09APL-00000-00032 Decker Appeal of MPC Denial

Related Cases: 09APL-00000-00020 08BAR-00000-00145

Santa Barbara County Board of Supervisors June 22, 2010

North Elevation

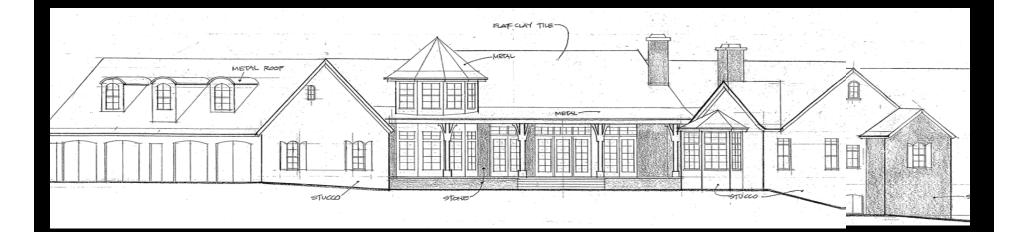
- a. Residence is inappropriate; too wide and bulky
- f. Orientation of residence is inappropriate
- g. Landscaping does not adequately screen the project or resolve the design issues
- h. Finished floor elevation is too high
- j. Roofline is not compatible with neighborhood and not consistent with the inspiration of design style

FAR Study

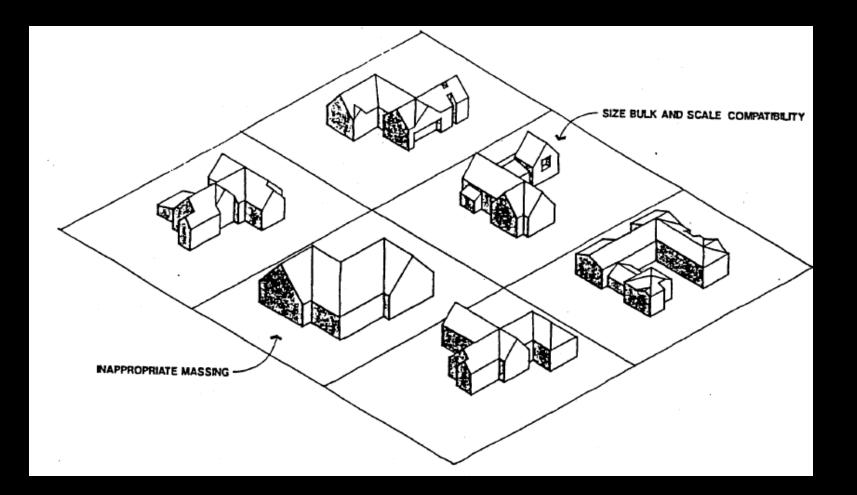
- Appellant Statement:
 - FAR and bulk consistent with neighborhood
 - FAR should only be compared to lots of similar size

- FAR is not the only design issue in compatibility
- Other issues discussed by MBAR and MPC:
 - Design of residence is too bulky and massive
 - Ridgeline too high and needs broken up
 - Entire house is oriented in wrong direction
